MODEL BENTLEY MARK VI

STONE GUARDS ON REAR WINGS AND SILL.

**Bulletin**

STONE GUARDS ON REAR WINGS AND SILLAMENDMENT.

STONE GUARD IN POSITION.

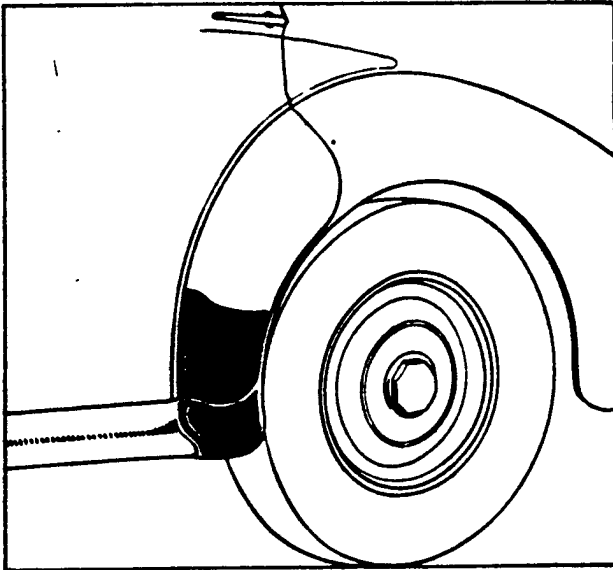
Moulded rubber stone guards on the front of the rear wings and the rear end of the sills are now a standard fitment. Some cars may not have been fitted with them, in which case they may be fitted on request. In such cases they may be obtained in sets from Hythe Road Service Station together with the requisite quantity of the materials necessary for affixing them.

As the Bostik Company's preparations mentioned in Service Bulletin BB-3 are suited only for factory use where it is possible to handle a number of cars simultaneously, an alternative procedure is desirable when dealing with odd cars.

In these instances Bostik C adhesive No.252 is recommended. This can be supplied in 8-oz. tubes. sufficient for fixing one set of Stone Guards.

No primer is needed, but the wing and sill surfaces must be thoroughly cleaned and degreased, after which a thin coat of No.252 adhesive is applied to both metal and rubber, the latter being previously roughened.

The coated surfaces must be allowed to dry for 45 minutes before fixing.

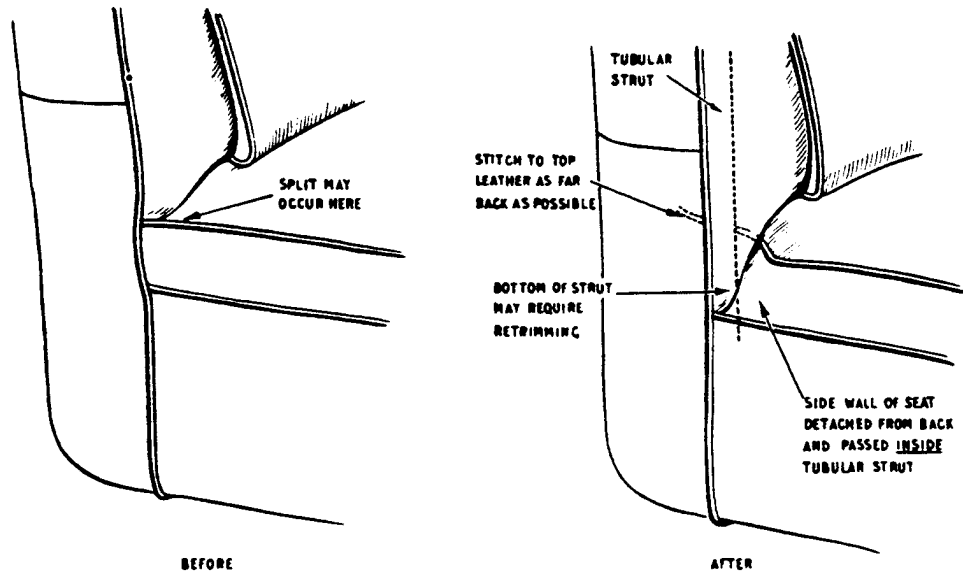
There have been one or two instances where the front seats have split at the rear corners where the top leather is stitched to the side panel. The reason for this is that the side leather is anchored to the back of the seat on the outside of the framework and cannot flex inwards sufficiently to follow up deflection of the top leather.

An alteration has therefore been made as shown in the drawing herewith. It will be seen that the side wall is now detached from the back and is passed inside the tubular strut. This alteration can be applied to existing seats in the event of any complaint of splitting.

1. Remove seat back millboard with carpet and hide.
2. Take side wall of seat cover inside the tubular strut and "french" securely to the top of the cover and piping. (This will allow the side wall to flex with the seat cover instead of being constrained by the tubular strut.)
3. It may be found necessary to cut a small portion of surplus hide from the rear of the cushion cover to enable you to cover a portion of bare tube which may be left exposed. This is only a matter of an inch or so of hide and may not be necessary in all cases.
4. Replace the millboard seat back together with the carpet, using the same seat back hide which is also refrenched round the top edge of the seat back.

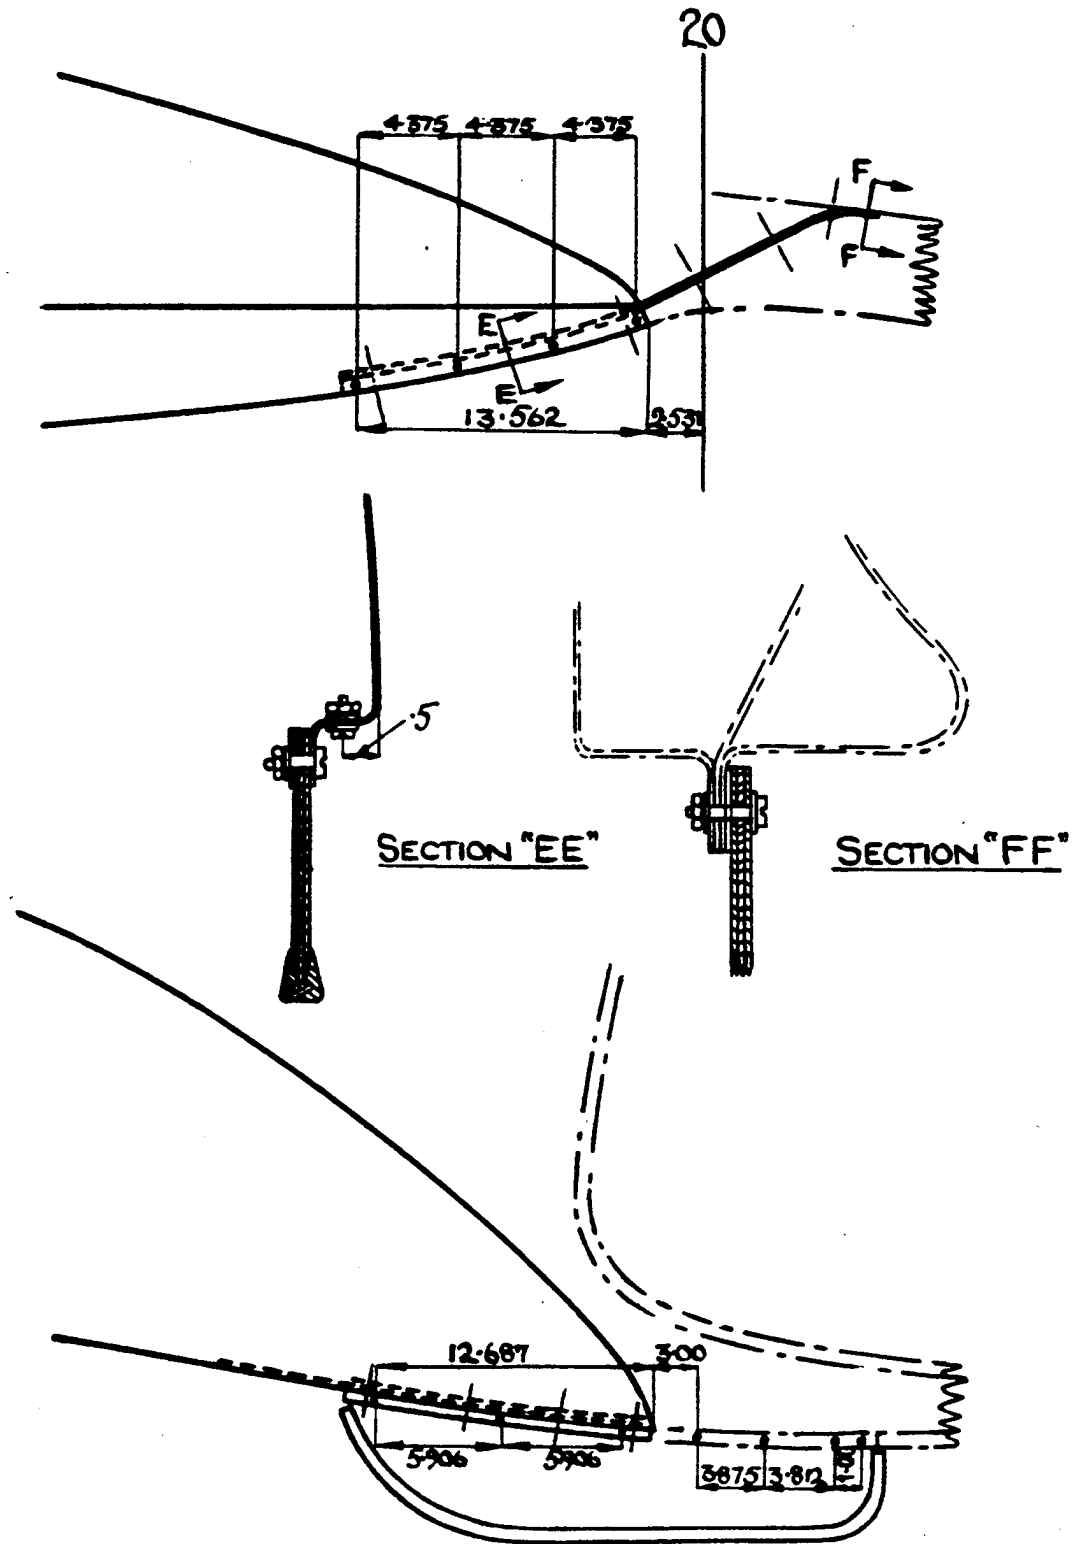
Front wing mud flaps are now fitted to all cars being manufactured with Bentley standard coachwork.

The mud flaps are fitted to the rear underside of the front wings, the method of attachment being by angle plates and 2-BA bolts and nuts, the positioning of these may be noted from the attached drawing.

Section through rubber seal, showing correct methods of sticking seal in position.

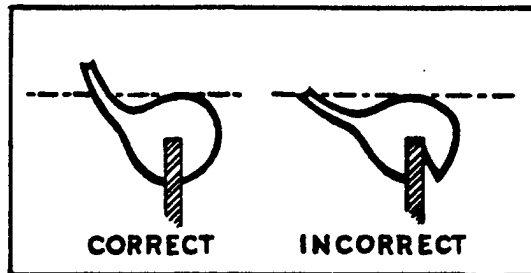
Briefly, this consists of fitting a new rubber seal, smoothing off with paint fillers etc. the underside of the ventilator lid which contacts the rubber seal, and then, very carefully re-assembling the ventilator to ensure 100% contact with the rubber seal when in the closed position.

- (iv) Stick the new rubber sealing strip in position with Bostik or other suitable waterproof adhesive. This operation will have to be very carefully carried out, as it is possible to stick the rubber in position in such a way that the lip is level with the main body of the seal instead of sticking up above it. (See illustration)

Also, before allowing the adhesive to set, make sure that the rubber is so positioned that it will contact the lip of the ventilator all the way round. This can easily be checked by placing the ventilator in position and then trying to rock it.

NEW SEAL LYING SIDWAYS AS APPLIED TO TRUNK DOOR, EDGE 'D'

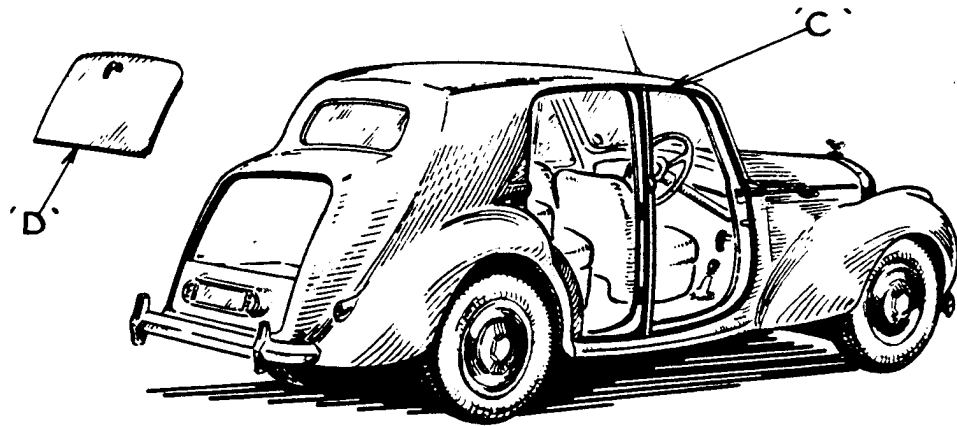
A new type of sealing rubber for the outer edge of all doors in the standard saloon has been developed, and it is desired to fit this new seal to customers' cars if trouble with the existing seals is encountered.

The new seal is a very soft, white, sponge rubber, roughly triangular in section, as shown at 'A' on the diagram and the apex of the triangle forms the contact point for the door, except in the special instance of the trunk door (see later). Owing to its spongy nature, the rubber is very susceptible to oil or grease.

When applying the rubber to the main doors, start at the centre post at the top corner (C) where a mitre joint is essential, then work downwards a short distance at a time, making sure that the apex of the section is lying in a straight line, owing to the extreme flexibility of the rubber this requires care. Only right-angle bends need a joint as the rubber will accommodate the others. The action of the door shutting tends to push the seal sideways, particularly on the length above the top hinge on the centre door post, so it may be found necessary to reduce the volume of the rubber by cutting a thin layer off the base of the triangular section with a pair of scissors. This operation must be carried out before the adhesive is dry and the seal must be pulled away carefully as it readily tears.

The lower edge of the trunk door (D) which makes a joint with the upper edge of the spare wheel compartment lid requires the special treatment shown on the diagram whereby the rubber is applied lying sideways, as there is insufficient room for the rubber to be applied normally if the spare wheel compartment lid is to shut properly.

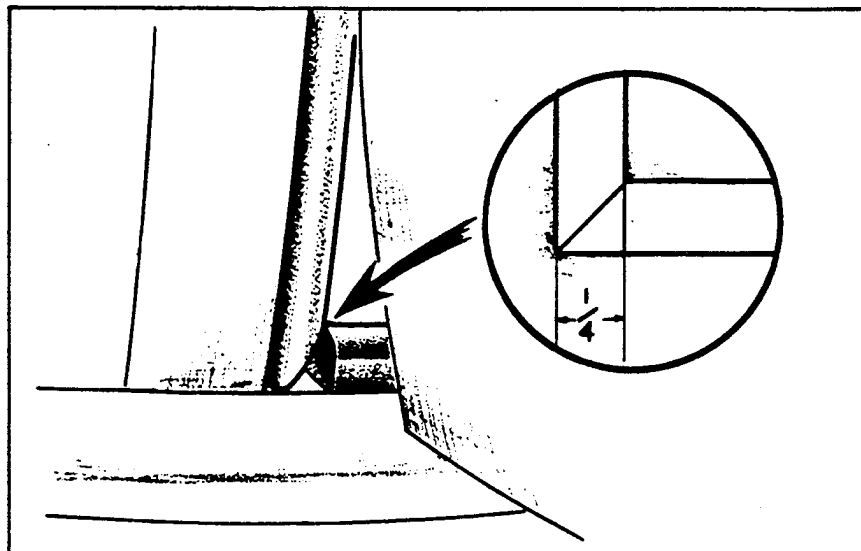
Investigations have shown, that in all these cases, the cars concerned were fitted with the later type soft sponge, triangular section door sealing rubbers, and that the natural tendency for this sponge rubber to spread rendered it impossible for the waste water to drain away while the doors were closed.

In order to compensate for this tendency to spread, and at the same time provide adequate means for drainage during wet weather, all current Standard Saloons in production have the bottom sealing rubber along the outer edges of the sills "cut back", leaving a gap of approximately  $\frac{1}{4}$ " at the point of juncture with the vertical sealing strip at the foot of the centre door pillars as shown in the attached sketch.

Retailers are advised, therefore, when dealing with complaints of such a nature from owners of earlier models of Standard Saloons, to cut the existing lower door seals to conform with the current procedure.

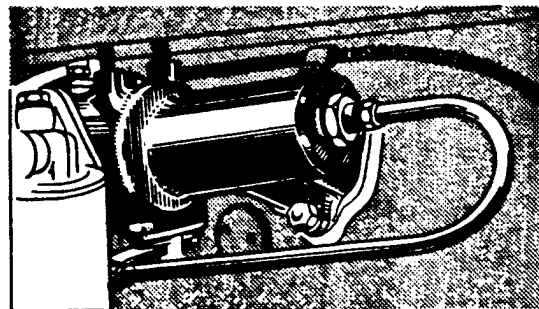
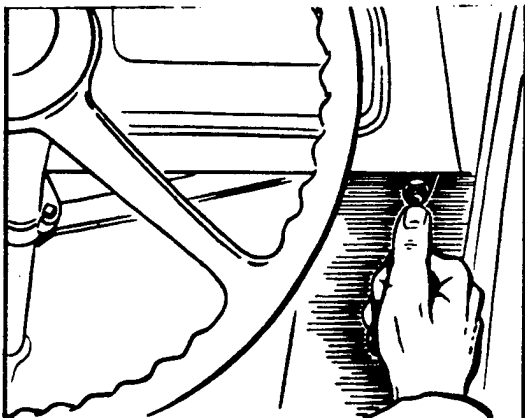
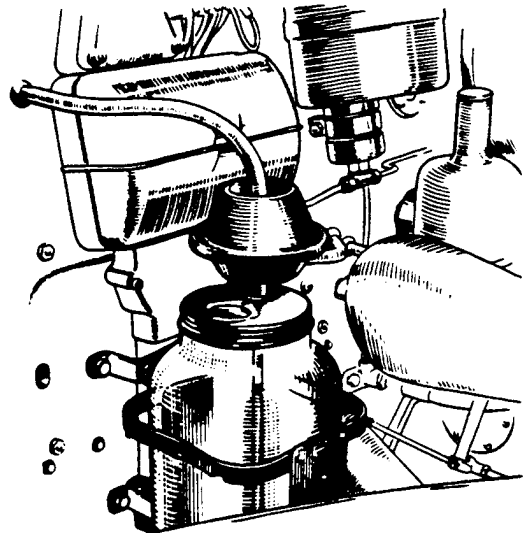
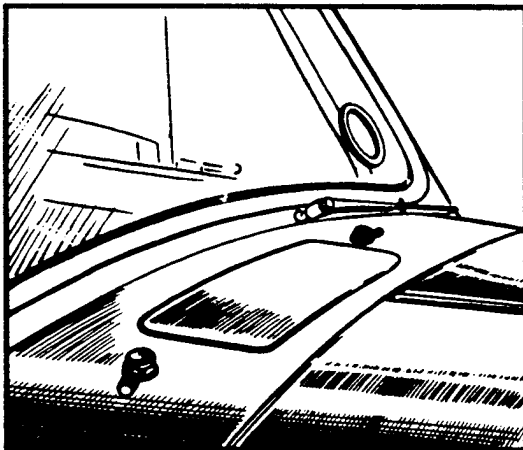
Subsequent to the publication of Service Bulletin BB-66, it is felt that a certain degree of uncertainty exists regarding the correct manner of fitting the two runs of rubber hosing between the diffusion chamber and the control button and tee-piece on the spray unit line.

With this in mind, it has been decided to clarify the diagrammatic instructions given in Fig. 7, page 4, of the original issue.

Failure to observe this will only result in the functions of these two units being reversed, i.e. air being expelled through the spray nozzles and water being injected into the induction manifold.
